# LLOYD'S REGISTER OF SHIPPING

## ALTERATIONS TO CONDITIONS OF ASSIGNMENT OF LOADLINES

Ship's Name S.S. "HILARY"

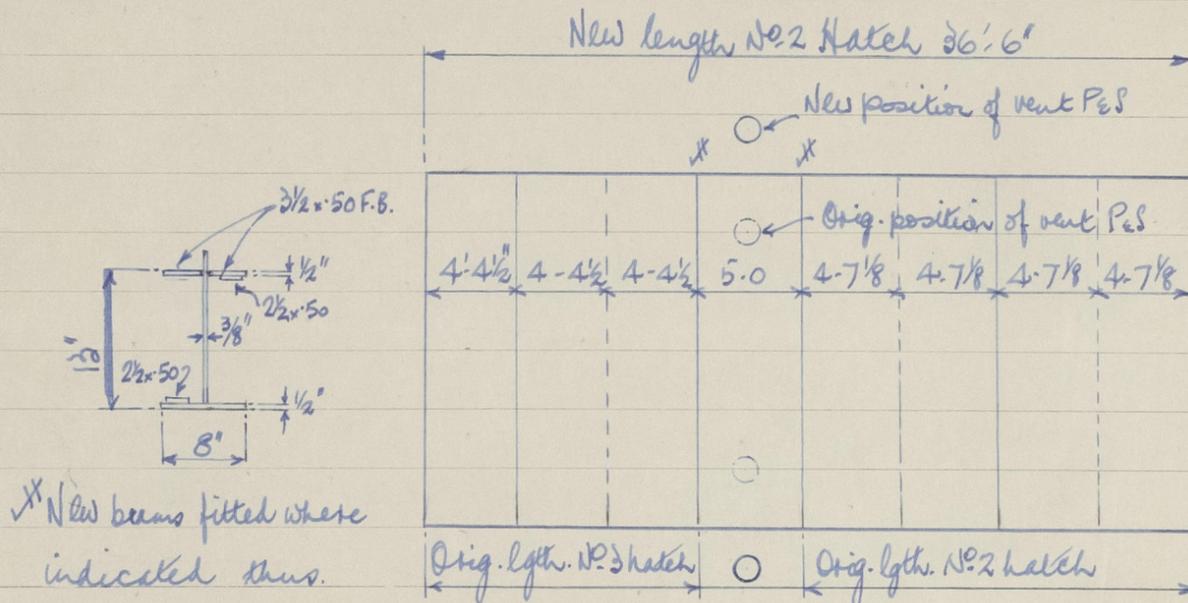
No.2 and No.3 hatchways on upper deck joined to form one hatch.

Hatch side stays, batten cleats, hatch beams & beam shoes, wood covers and hatch tarpaulins now fitted in accordance with Rule requirements to suit new dimensions of hatches.

Two new hatch beams fitted, scantlings and spacing as follows:—
